Rezoning Transportation Analysis

Petition Number: 2019-168

From: Felix Obregon, PE
fobregon@charlottenc.gov
704-432-5729

Date	Description
12-18-2019	First Review
01-14-2020	Second Review (FO)
02-18-2020	Third (WB)

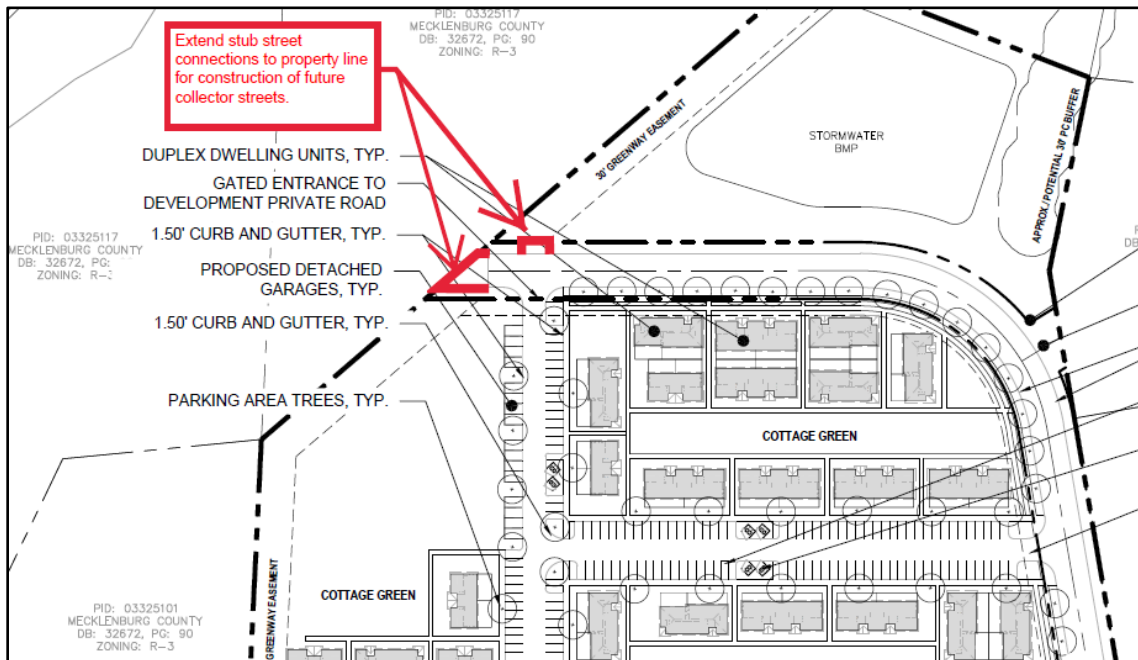
4. **Updated based on site plan (1/14/2020)** The proposed Collector Street included in the plan should be in accordance with the current Charlotte Land Development Standards for a local collector, [U-07 REV 17](#). The collector street should have a similar alignment to the original site plan.

5. Per Chapter 20 Subdivision ordinance, the petitioner should revise the site plan and conditional note(s) to commit to construct stub connections to extend to the property line for construction of future collector streets.

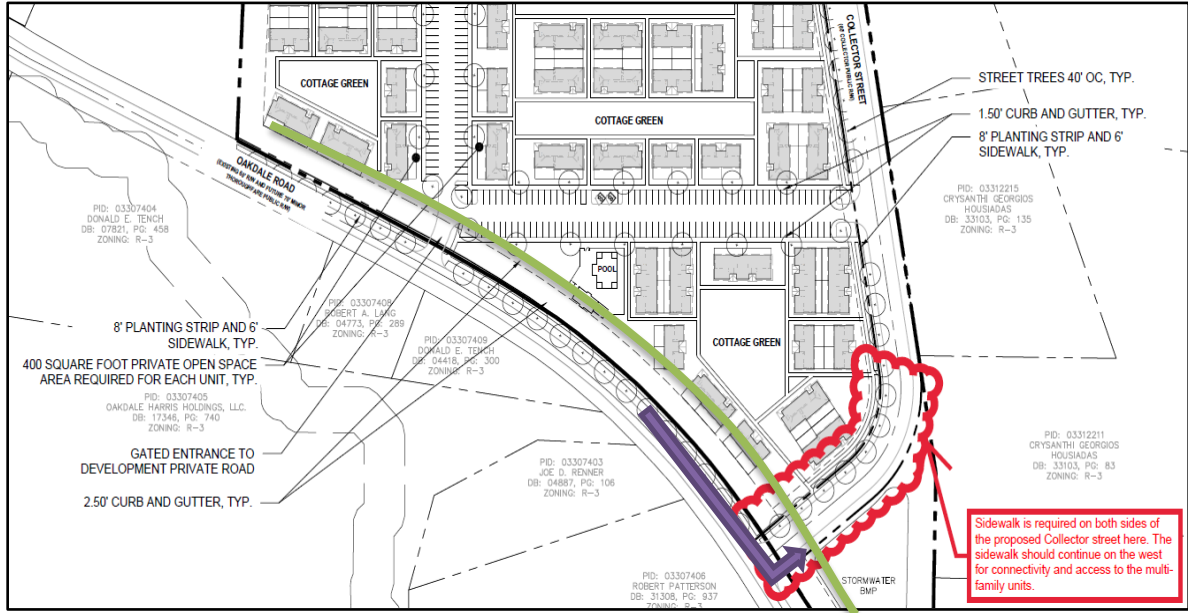
7. To comply with the council adopted Charlotte Walks and BIKE Policy, CDOT is requesting the petitioner construct a 12 foot multi use path along the Oakdale road. See multi use path shown above in green.

8. Per NCDOT, the petitioner should revise the site plan and conditional note(s) to include an eastbound left turn lane from Oakdale onto the proposed Collector street. See left turn lane shown above in purple.

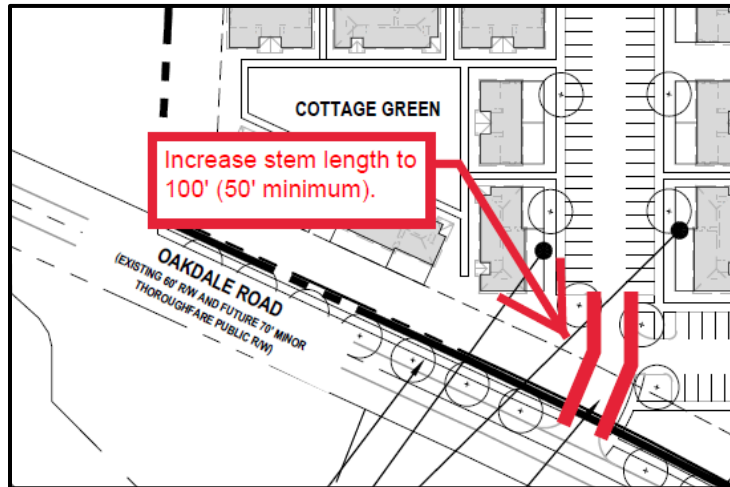
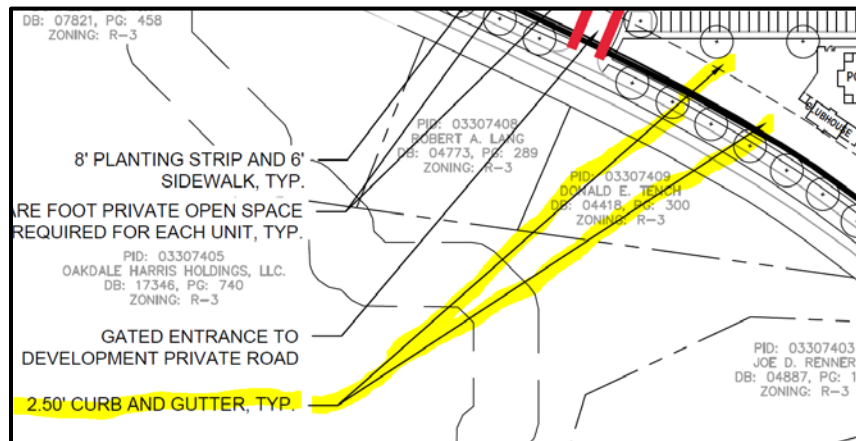
11. The petitioner should revise the site plan and conditional notes to correctly show label the curb and gutter locations on the site plan. The site plan is showing a label of curb and gutter that is pointing to where there is not curb and gutter.

12. The petitioner should revise the site plan and conditional notes to provide a minimum of 40 feet (vehicle length) must be provided between the card reader and the street right of way, setback line, or back-of-sidewalk, whichever is greater. This will avoid vehicular conflict between pedestrians along the local road.

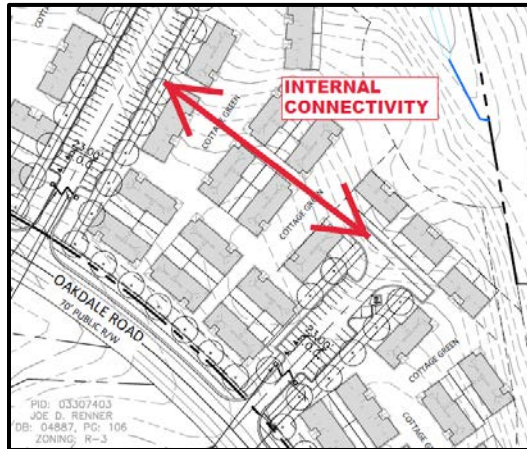
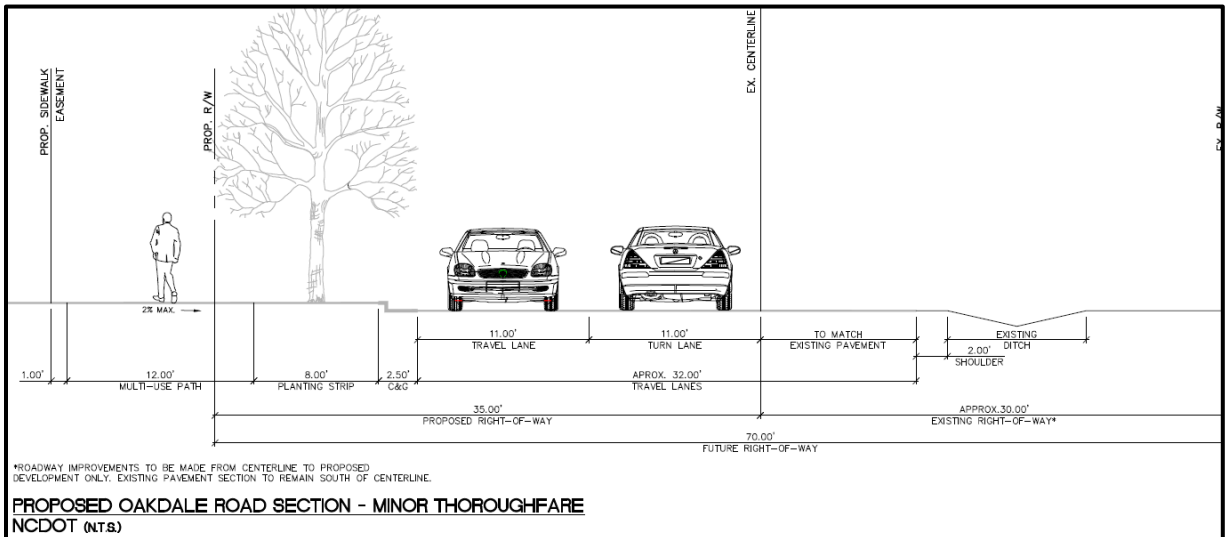
16. ~~Revised site plan based on site plan (1/14/2020)~~ The petitioner should revise the site plan and conditional notes to commit to provide internal vehicular connectivity between the different internal private streets.

17. ~~New Comment based on revise site plan (1/14/2020)~~ The petitioner should revise the site plan and conditional note(s) to eliminate the internal gates and/or provide a turnaround at each private drive. If gates will be kept, a 75' stem is needed prior to the gates with a turnaround.
18. ~~New Comment based on revised site plan (1/14/2020)~~ The petitioner should revise the site plan and conditional note(s) to provide an exhibit showing the Oakland Road roadway improvements and the NCDOT roundabout project to make sure they overlap with each other, and there isn't a conflict.
19. ~~New Comment based on revised site plan (2/11/2020)~~ The petitioner should revise the site plan and conditional plans to show the curb and gutter be a consistent distance across the entire frontage, instead of tapering at the property line, as per the typical provided for Oakdale Road Section.
